Historic Landmarks and Preservation Districts Commission

Report to the Committee

Case No: 19-COA-0047
Classification: Committee Review

Property Address: 2006 Frankfort Avenue

1905 Sanborn Map

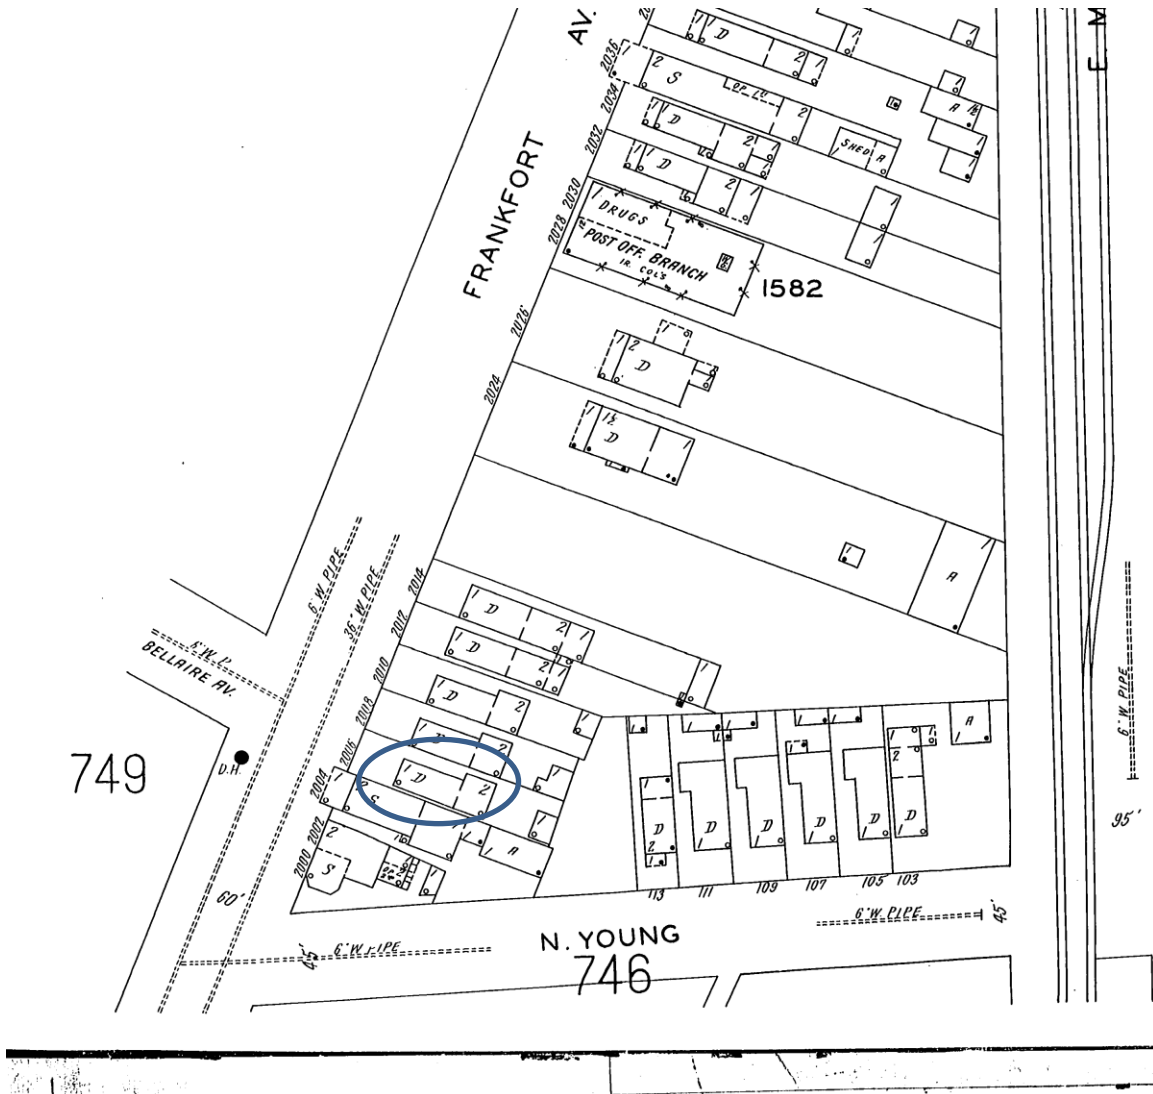
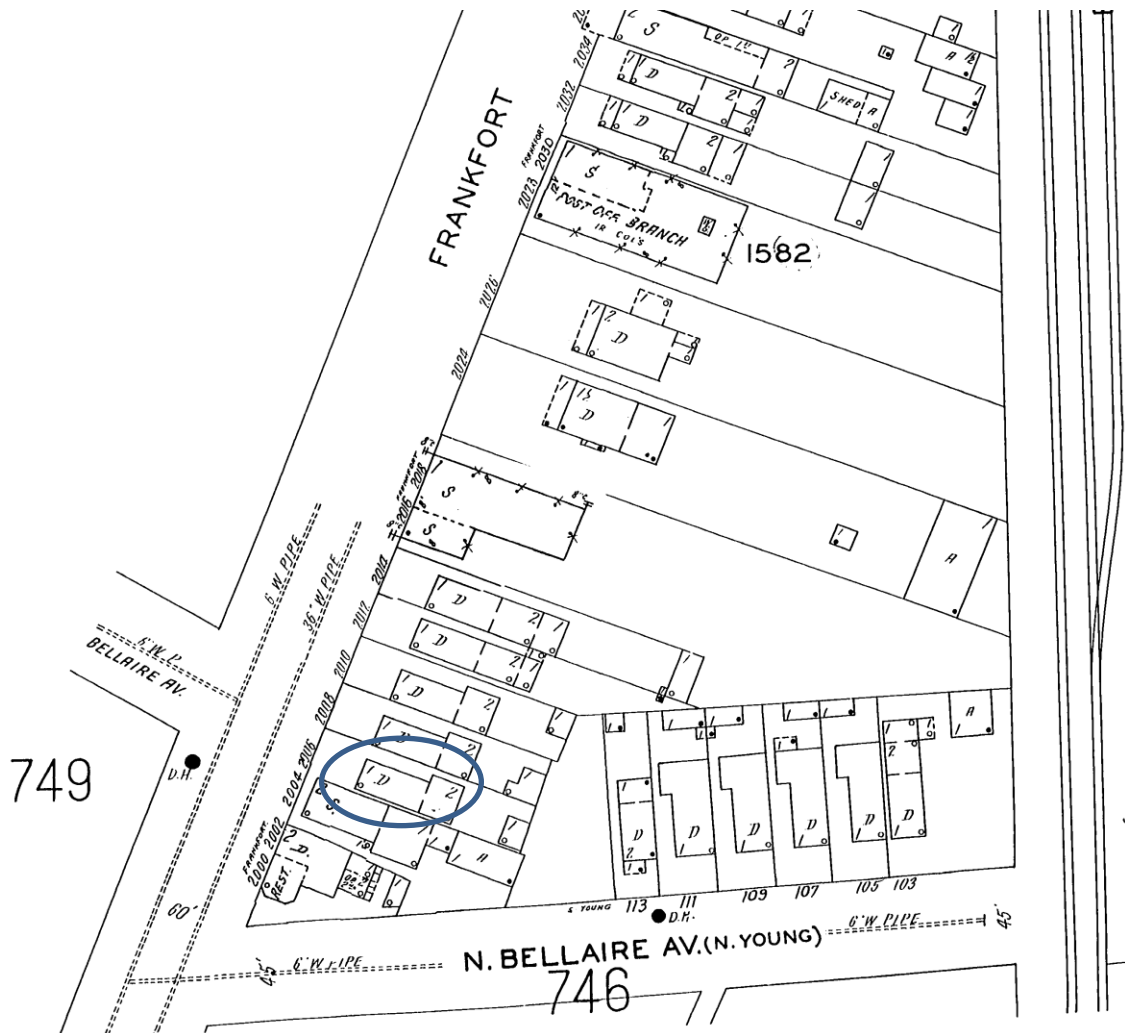
Removal of the existing porch complies with the Clifton **Porch** design guidelines. Based on building evidence and Sanborn Maps, this porch was added later than the original construction of the house, likely in the 1950s or 1960s. The roofline of the porch concealed the door and window hoods which were likely removed when the porch was constructed. Additionally, alterations to the existing porch have reduced its integrity due to the removal of railing and columns. The new porch will not have a roof. This will enable the reconstructed door and window hood to be
